PROPOSED MIXED-USE DEVELOPMENT  
(COMMERCIAL & RESIDENTIAL)  
404 BERLIN TURNPIKE  
BERLIN, CONNECTICUT

**To:** Maureen Giusti, Acting Town Planner  
**From:** Michael S. Ahern, P.E., Public Works Director/Town Engineer *MSA*  
**Date:** February 17, 2021  
**Re:** 404 Berlin Turnpike – Mixed Use Development

Re: ***Zoning Change, Site Plan and Special Permit Application Review***  
404 Berlin Turnpike  
WMC Project No. 21010.10

Re: Third-Party Review – Zone Change, Site Plan, and Special Permit Application for 404 Berlin Turnpike

**SK-27.**

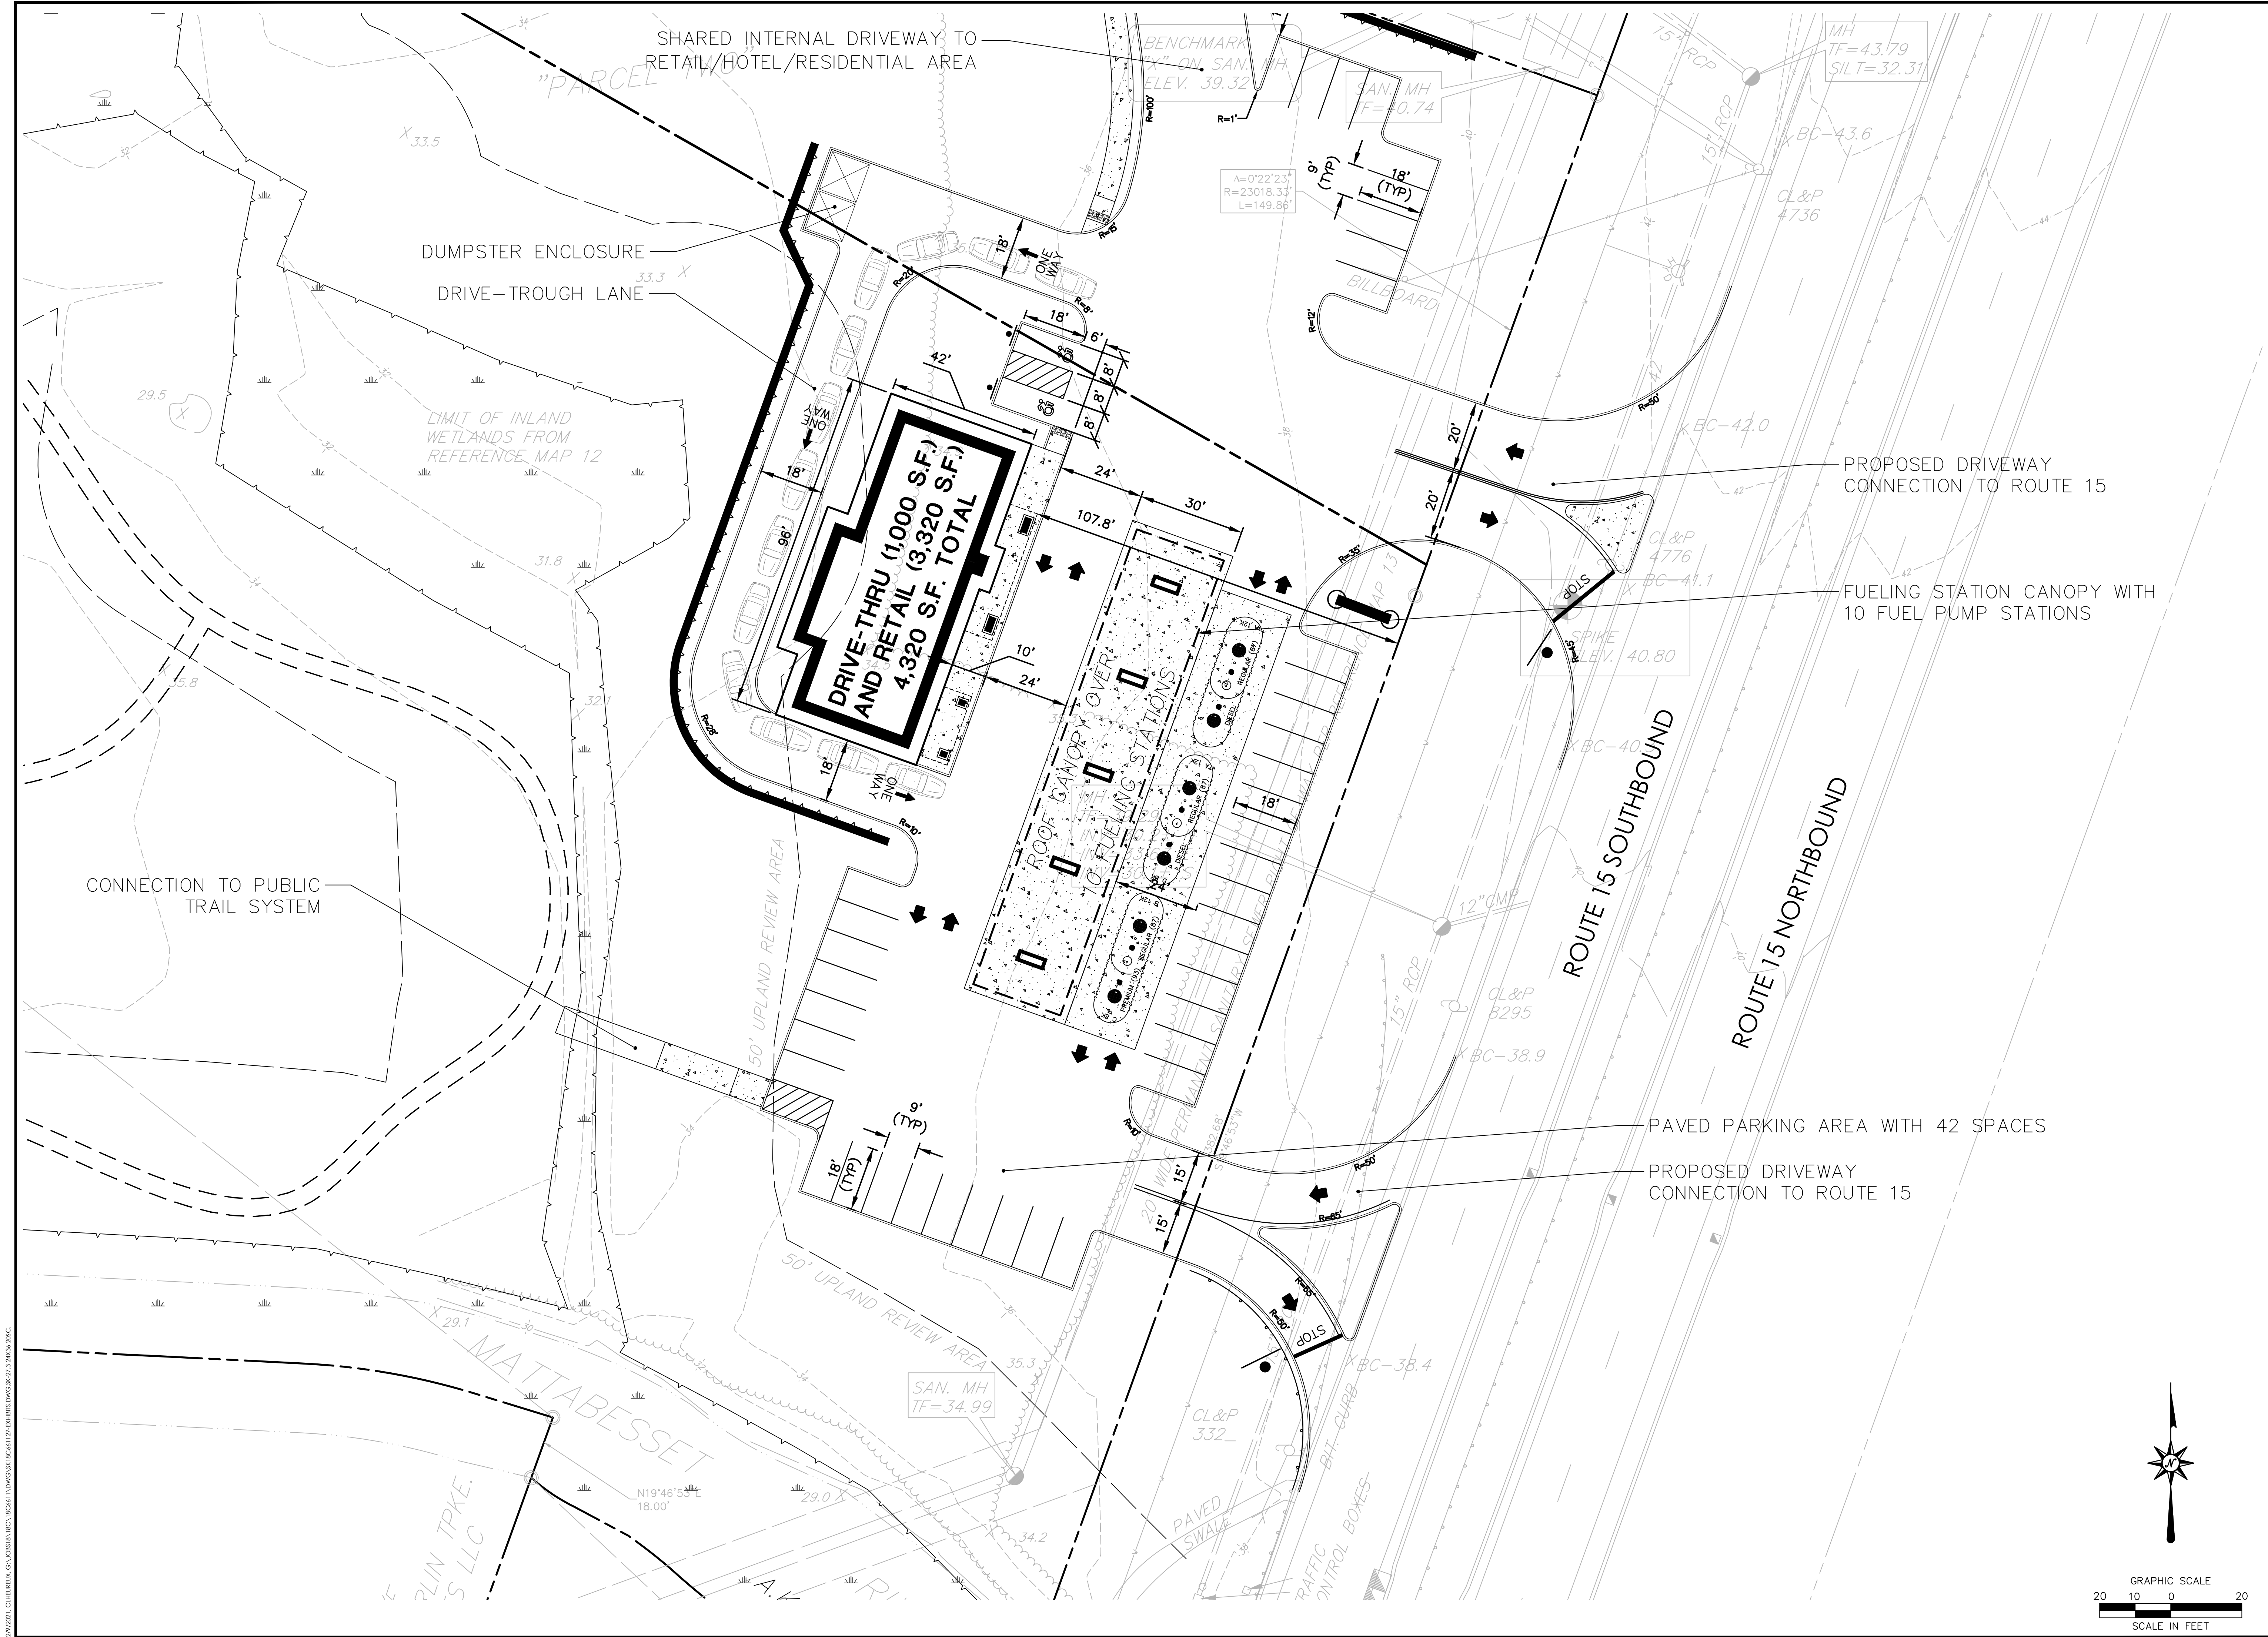
These comments are provided in addition to the peer reviews underway by Town consultants, and are focused on the sanitary pump station that is operated by the Berlin Water Control Commission (BWCC).

**Background:** The sanitary pump station is located at 436 Berlin Turnpike on a triangular-shaped property surrounded by the proposed development to the north, south, and west. This property has an access easement from the Berlin Turnpike benefitting the Applicant property, which the Applicant proposes to extinguish in return for an easement across the western portion of the BWCC property (for an internal roadway). The Applicant and BWCC staff and consultant discussed reworking the easements and other elements of the plan, but no agreements have been made. See below for related comments:

- Easements – BWCC and Town engineering staff met with the Applicant's planning and engineering team on a number of issues on November 11, 2020. One of the requests from the Town was for the Applicant to provide a summary of the proposed/revised easements involved in the easement "swap" noted above. The request, at that time, was for an outline of the various easements conceptually discussed with the Town. This summary has not yet been provided. Considering where this project is in the approval process, Staff are now requesting draft easement language and associated draft easement mapping for BWCC and Corporation Counsel review. One element of the easement discussion is to allow periodic use of the internal roadway(s) by the BWCC for future work on the pump station, which will require the use of a crane and other equipment.

- Odors – The sanitary pump station operation has associated odors in its vicinity. It may be advisable for the Applicant's team to evaluate the odor impact on the proposed development.
